# WILLIAMSON COUNTY, TEXAS

CHANGE ORDER NUMBER: 4

Project: 22IFB57  
CR 401  
Roadway: Reconstruction  
CSJ  
Number: \_\_\_\_\_

#### **Change Order No. 4 Reason for Change**

FED.RD. DIV.NO.	FEDERAL AID PROJECT NO.		SHEET NO.
6			GW-01
STATE	DISTRICT	COUNTY	
TEXAS		WILLIAMSON	
CONTROL	SECTION	JOB	HIGHWAY NO.
			CR 401

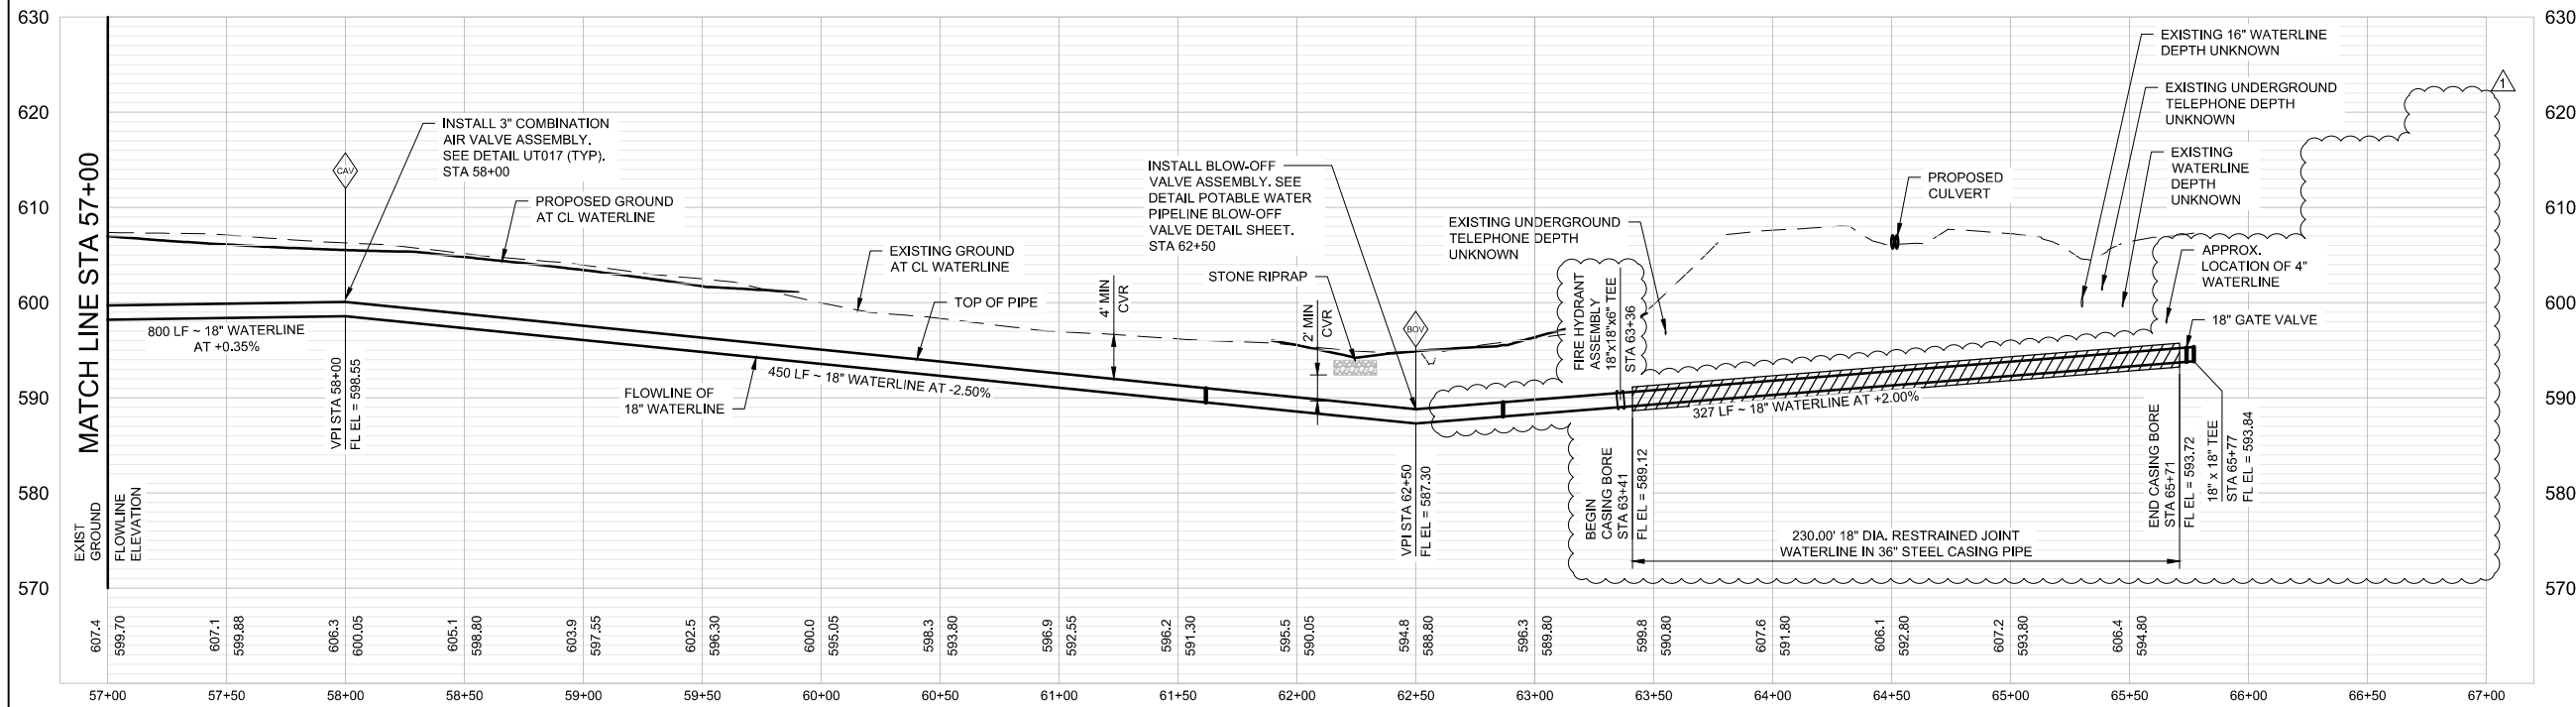
7. New or revised plan sheet(s) are attached and numbered: GW-01, W-07, W-07A, W-07B

PLAN - 18IN WATERLINE RELOCATION

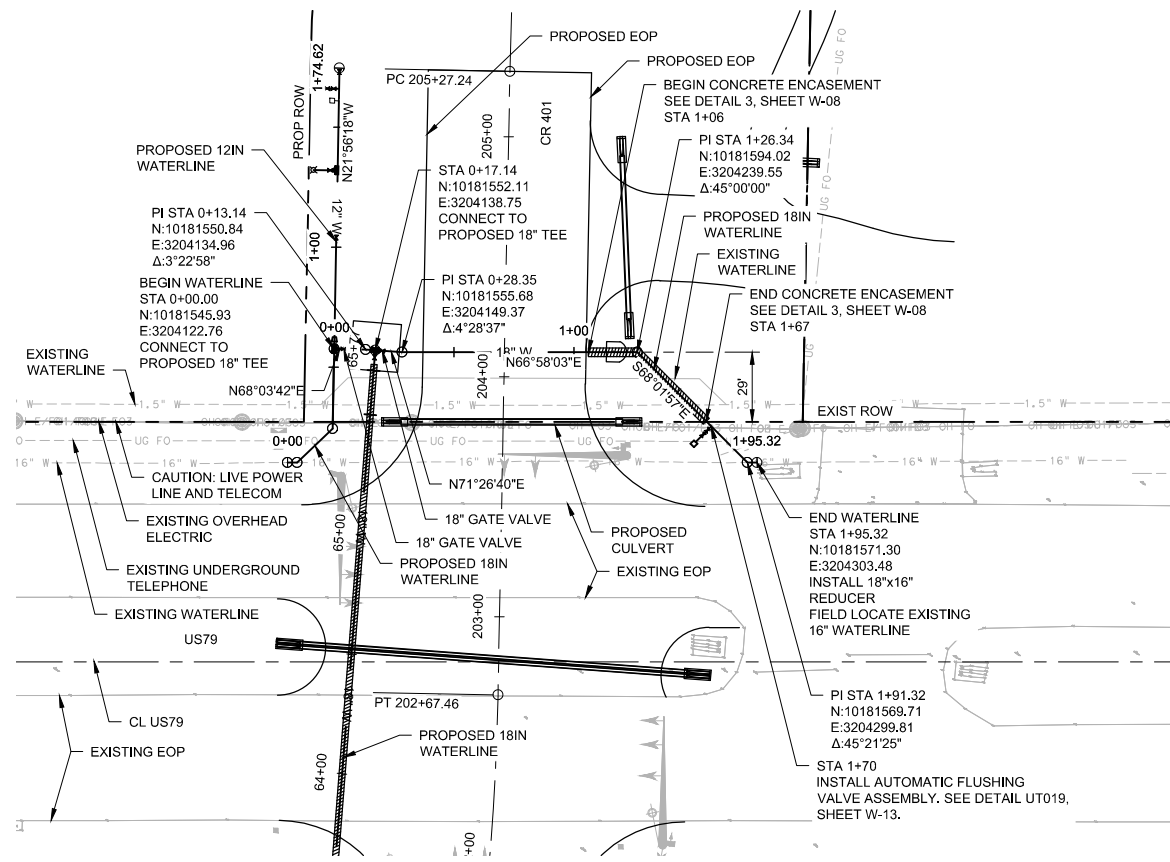
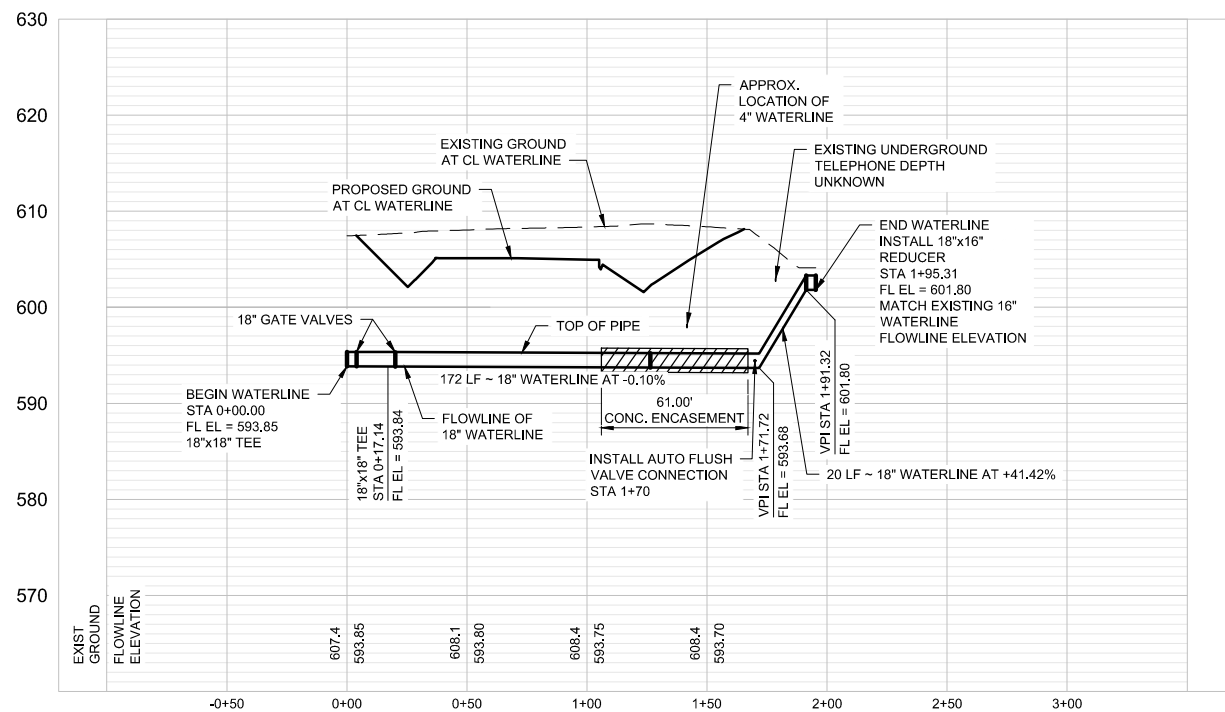
**2G. Differing in site conditions. Unadjusted Utility (Unforeseeable)** This Change Order adds new items to the Contract to adjust the existing 16in City of Taylor water line on the north side of US 79 which is in conflict with the proposed pavement and ditch cuts. **4B. Third Party Requested Work.** An additional 6in line and fire hydrant assembly are being added at the request of the City of Taylor.

This Change Order revises and adds additional items to the Contract for the adjustments needed to the City of Taylor water line on the north side of US 79 that conflicts with the proposed roadway and ditch cuts. This line is also being upsized to stay consistent with the proposed water line on CR 401.
